18 February 2021

**RE: PLANNING PROPOSAL SUBMISSION  
2020SNH003-NORTH SYDNEY-PP-2020-74  
263-283 ALFRED STREET & 4 LITTLE ALFRED STREET, NORTH SYDNEY**

**Figure 1 – Interface with Little Alfred Street**

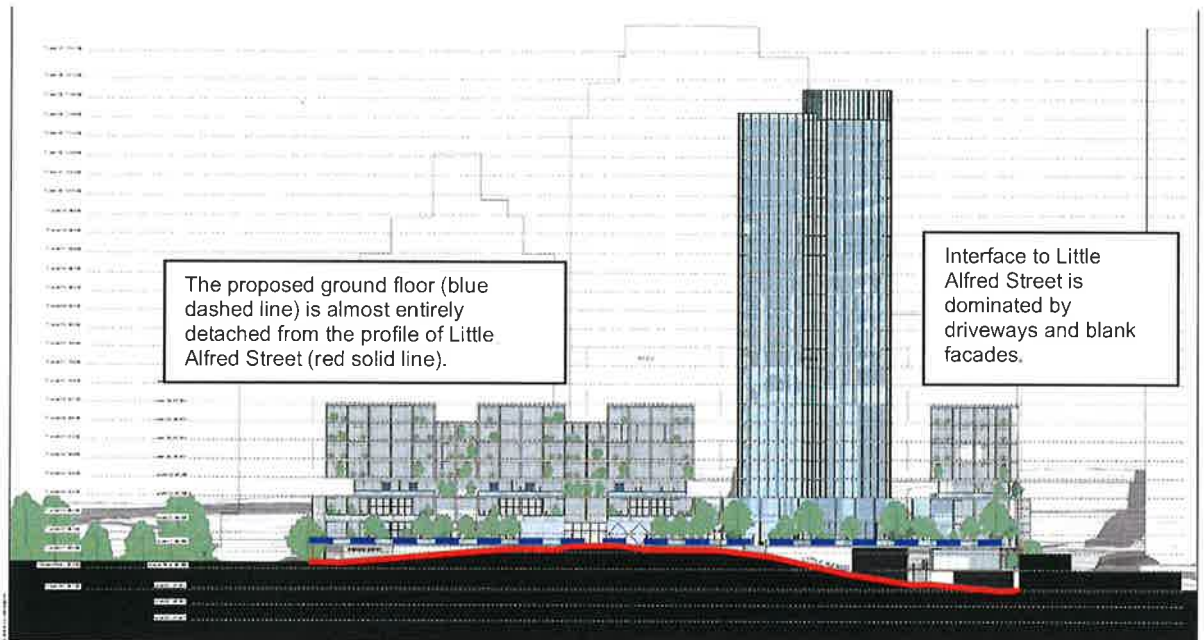
This nil setback results in the “closing in” of Little Alfred Street, with no additional space for pedestrian access and no deep soil to accommodate large canopy trees, which was also identified as a desirable outcome in Council’s unendorsed Planning Study for the Precinct. In addition, it would prevent the ability to deliver a fine-grain built form to positively interface with the adjoining heritage conservation area.

Furthermore, the proposed setbacks would result in an approximately 6m deep building, fronting Little Alfred Street, which provides poor potential for use as either residential or business uses. In addition, it removes the ability to establish a landscaped buffer to the Whaling Road Conservation Area.

- provide a minimum 3m whole of building setback to the lot boundary to improve pedestrian safety and amenity at ground level and achieve a landscaped green buffer to the conservation area along Little Alfred Street. This setback should extend below ground level to enable deep soil for large tree canopies.
- Provide at least a 7.5m setback from the upper levels of Site A with the conservation area to the north, consistent with the minimum ADG requirement for unhabitable facades and including an additional 3m due to the change in zoning. This setback should provide vegetated transition to the conservation area in line with the ADG requirement.

**Figure 2 - Interface with Little Alfred Street**

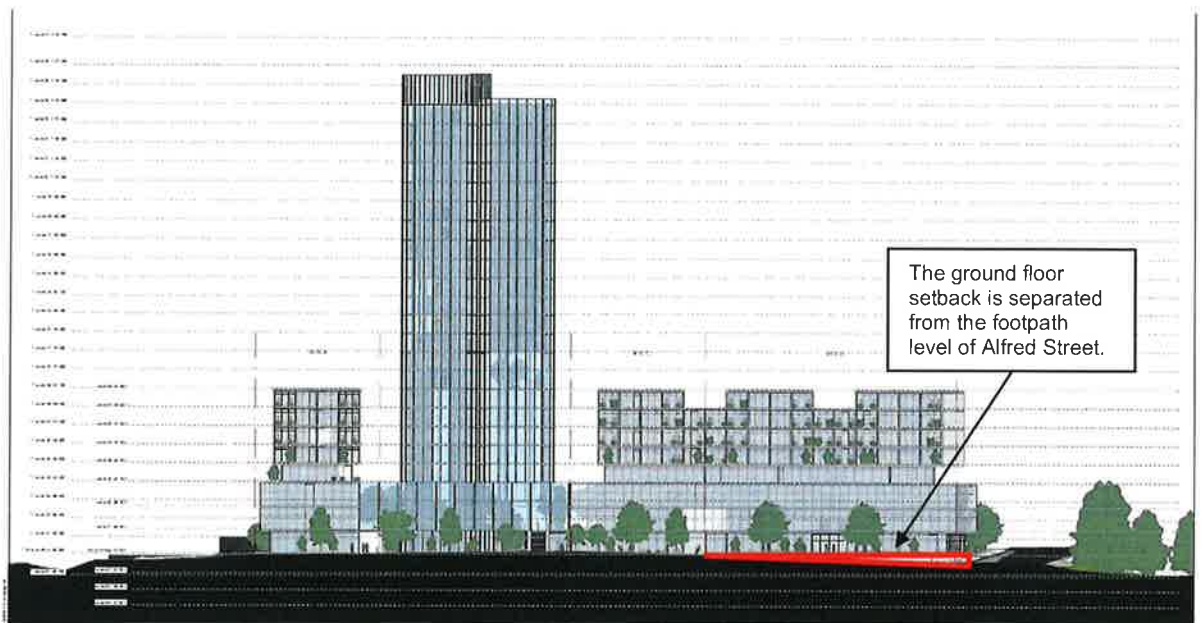
However, in rationalising the built form levels across the length of the site, rather than working with the significant level changes of the street and laneway, the proposal would result in exposed basement/lower floor levels that create a hard, continuous edge along the eastern frontage to Little Alfred Street for approximately 80% of the frontage. Even if just looking at the basement level, it rises a full floor to the southern end of Little Alfred Street and two whole floors to the north (Figure 1). Whilst less extreme, it creates an awkward interface along the southern end of Alfred Street (Figure 2).

Figure 3 – Extract of draft DCP height controls

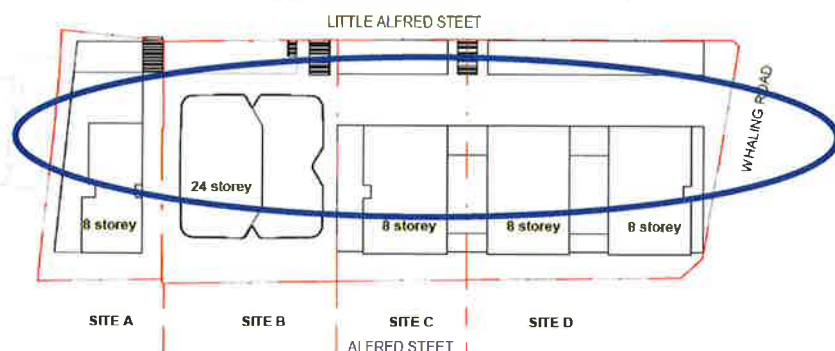
Whilst an FSR control will somewhat temper building heights across the Precinct, there are insufficient controls to ensure an appropriate built form transition to the east. Despite the proposed DCP amendment seeking to identify a number of storeys across the Precinct, no height controls have been established for the proposed built form fronting Little Alfred Street (refer to Figure 3).

To ensure a greater level of clarity and certainty, split height controls should be established across the eastern portion of the site to set depths from Little Alfred Street to ensure the desired built form outcomes are achieved. This would be best achieved by further revisions to the Height of Buildings Map to NSLEP 2013 and supported by additional details in the proposed DCP amendment. Such an amendment would warrant a re-exhibition of the planning proposal.
